**MONTGOMERY COUNTY PLANNING BOARD**  
THE MARYLAND-NATIONAL CAPITAL PARK AND PLANNING COMMISSION

Subject: Wheaton Library, Community Recreation Center and Neighborhood Park  
Mandatory Referral No. 2016004

**Wheaton Library, Community Recreation Center and Neighborhood Park, Mandatory Referral, MR2016004**

*Proposed Site Layout*

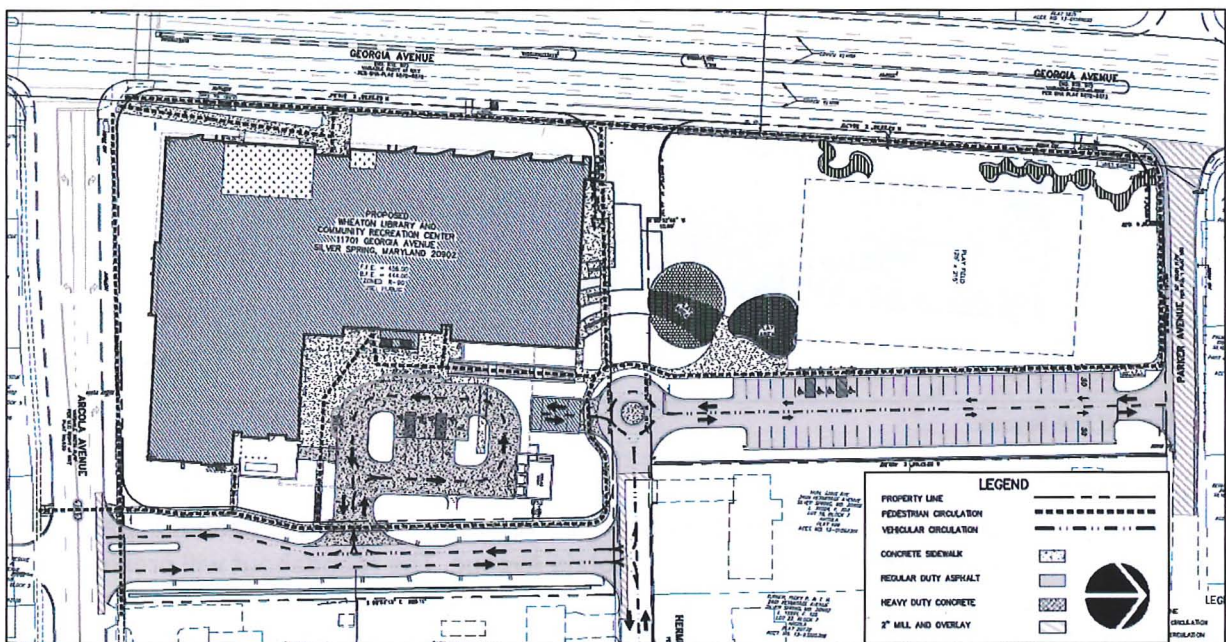
As currently proposed, the surface parking lot does not conform to this section of the Zoning Ordinance. The design does not provide any landscaped islands or protects and incorporates existing trees into the design of the parking lot. The location of the proposed elm trees along

the parking lot does not provide the minimum tree canopy of 25%. The surface lot is setback a minimum of 10 feet from the shared property line with residential uses to the east, and the existing fence along the property line will remain meeting the Zoning Ordinance requirement. The proposal does not include the specified canopy tree every 30 feet on center or understory trees along the shared property line; the area is proposed as a combination of grass sod and stormwater management facility.

As described in the paragraph above, the proposed surface parking lot does not meet some of the zoning requirements for landscaping and tree canopy. While landscaped islands are required by the ordinance, preservation of trees is also a strong desire and priority for this site. Staff recommends that the Applicant explore the feasibility of providing additional perimeter planting abutting residential properties.

As currently proposed, the application provides 78 onsite parking spaces than required by the Zoning Ordinance. Another 76 parking spaces are available for overflow parking across Arcola Avenue. Staff recommends the Applicants reduce the amount of surface parking area, which will allow more land area to accommodate other facilities and goals including playing field, landscaped islands, stormwater management facilities, tree canopy coverage and preservation of existing mature trees to meet the requirements and intent of the zoning section.
